# UNITED STATES PATENT AND TRADEMARK OFFICE

APPLICATION NO.	FILING DATE	FIRST NAMED INVENTOR	ATTORNEY DOCKET NO.	CONFIRMATION NO.
10/642,628	08/19/2003	Michael P. Dallmeyer	051252-5253	3758

**Office Action Summary**

FIG. 1

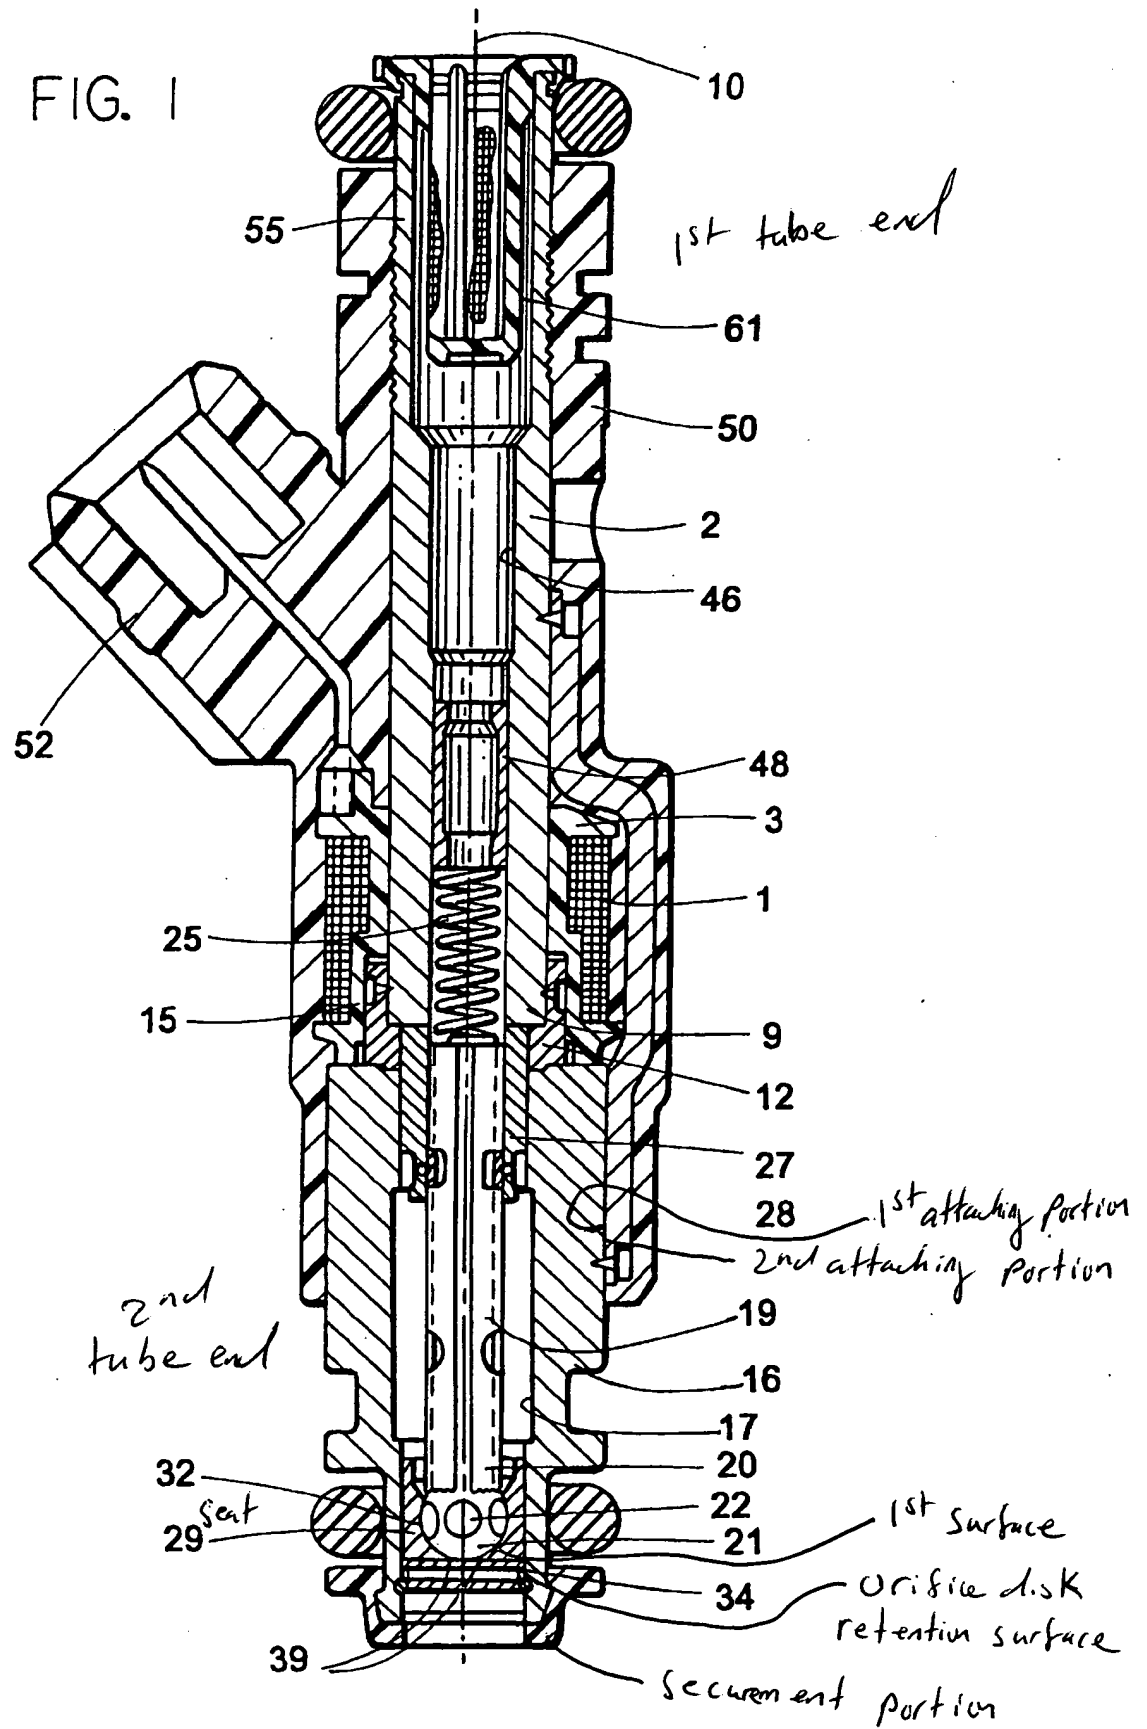
Gesk et al. show a fuel injector comprising:

- a coil group subassembly being independently testable, the coil group subassembly including a solenoid coil 1, a coil housing surrounding a portion of the solenoid coil, and a first attaching portion disposed on the housing; and
- a valve group subassembly being independently testable, the valve group subassembly including a tube assembly having a longitudinal axis extending between a first tube end and a second tube end, the tube assembly having a second attaching portion contiguous to the first attaching portion, the first and second attaching portions being fixedly connected proximate the second tube end, an armature assembly comprising armature 27, a non-magnetic tube 19, and closure member 21 disposed in the tube assembly, the armature assembly having a closure member, and a seat

assembly disposed in the tube assembly proximate the second tube end, the seat assembly including a flow portion, the flow portion extending along the longitudinal axis between a first surface and an orifice disk retention surface at a first length, the flow portion having a seat orifice extending therethrough, an orifice disk 34 coupled to the orifice disk retention surface so that the orifice plate is aligned in a fixed spatial orientation with respect to the flow portion, and a securement portion, the securement portion extending along the longitudinal axis away from the orifice disk retention surface at a second length greater than the first length (see Figure 1 attached herein). Gesk et al. also shows an inlet tube 2 having a first end and a second end being coupled to a valve body 12, the second end of the inlet tube having an end portion confronting an end portion of the armature, a filter 61, a resilient member 25, and an adjusting tube 48 as recited in claim 6, wherein the armature assembly comprises a non-magnetic tube 19 connecting armature 27 to the closure member 21 as recited in claim 8.

Gesk et al. also discloses welding various parts together for example parts 2 and 12 to create a strong bond. It would have been obvious to one having ordinary skill in the art

at the time the invention was made to have welded the surfaces together as recited to form a strong bond between the surfaces. The length of the weld as recited in claim 5 would have been an obvious matter of design choice.
